ADDRESS . . : 74 ROBERT BRANCH CIR
CONTRACTOR : R & K ANDERSON BUILDERS INC
OWNER . . . : AUSTIN CONSTRUCTION & DEV #23
PARCEL . . . : 08-0652- - -0097- -23-
APPL NUMBER: 06-50015050 CP NEW RESIDENTIAL (SFD)
DIRECTIONS : MILL BRANCH LOT 23. TAKE 401N TOWARD
FUQUAY RIGHT ONTO MILL BRANCH CIRCLE
LEFT ONTO ROBERT BRANCH CIRCLE LOT ON
RIGHT. -A.DRIGGERS

Subject: Lot 23, Mill Branch Subdivision
2300-sf± residence
Lot 23, Mill Branch Subdivision, Kipling, Harnett County, NC 27526
VSi # 06431

STRUCTURAL INSPECTION REPORT

**LOT 23 MILL BRANCH SUBDIVISON
2300-sf± RESIDENCE**

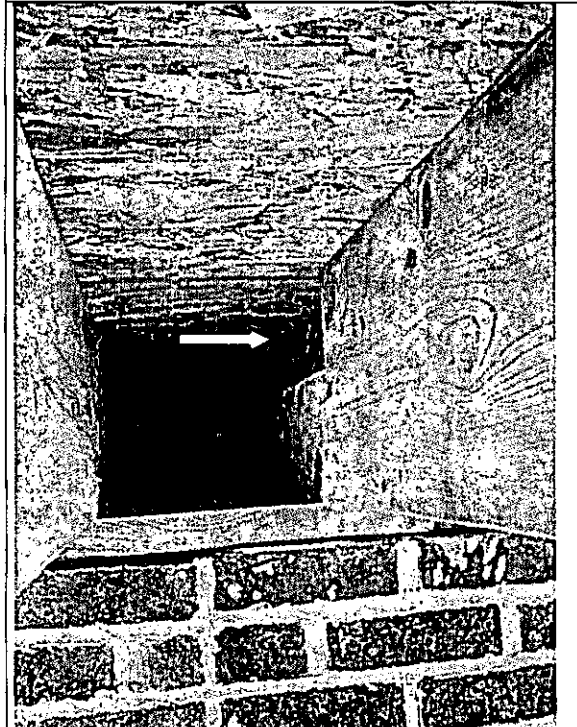
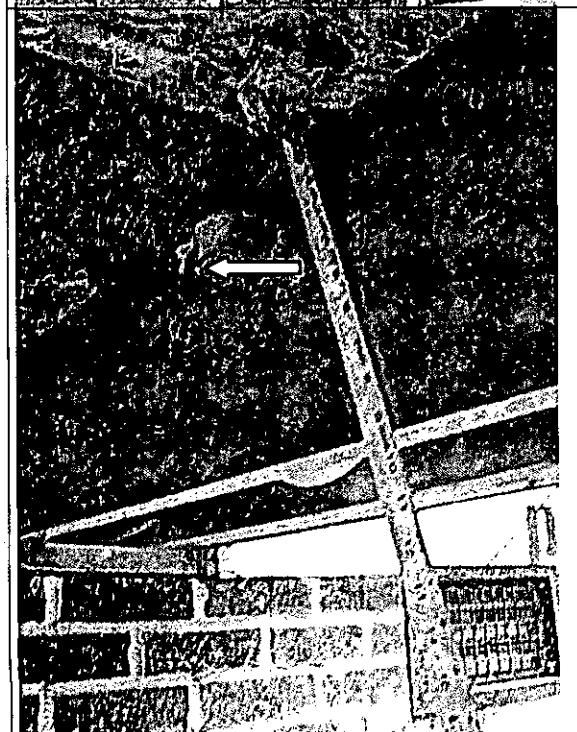
Photograph	Observations and Notes
	<p><u>Item 1</u></p> <p>Observation: The floor framing beneath the 7-stud built-up column at the right-side wall in the garage overhangs the foundation wall by 5 inches.</p> <p>Recommendation: Install a built-up column beneath floor framing at column.</p> <p>Refer to drawings in appendix for more details.</p>
	<p><u>Item 2</u></p> <p>Observation: The floor framing beneath the built-up column at the right-rear corner of the garage overhangs the foundation wall by 6 inches.</p> <p>Recommendation: Install built-up column beneath the floor framing at column.</p> <p>Refer to drawings in appendix for more details.</p>

PLAN AT MASTER BATHROOM

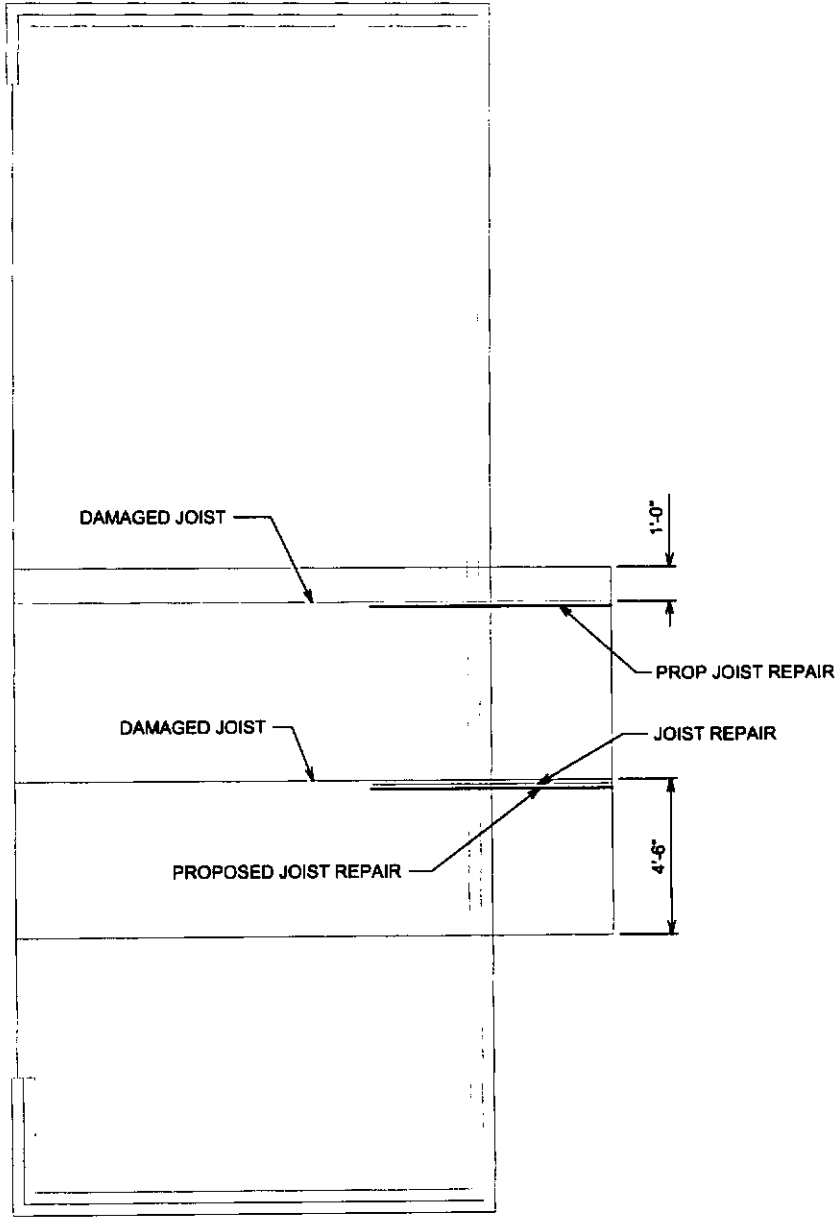
Photograph	Observations and Notes
	<p><u>Item 3</u></p> <p>Observation: A joist repair was observed beneath the cantilevered portion of the floor framing at the master bathroom, 2'-6" from the front wall. This repair conceals damage to original joist.</p> <p>Recommendation: Install a 2x10 joist beside repair.</p> <p>Refer to drawings in appendix for more details.</p>
	<p><u>Item 4</u></p> <p>Observation: A damaged joist was observed beneath the cantilevered portion of the floor framing at the master bathroom, 1'-0" from the rear wall.</p> <p>Recommendation: Install a 2x10 joist beside damaged joist.</p> <p>Refer to drawings in appendix for more details.</p>

1. ALL WOOD SHALL BE NUMBER 2 SOUTHERN YELLOW PINE.
2. ALL WORK SHALL BE IN ACCORDANCE WITH 2002 EDITION OF NORTH CAROLINA BUILDING CODE
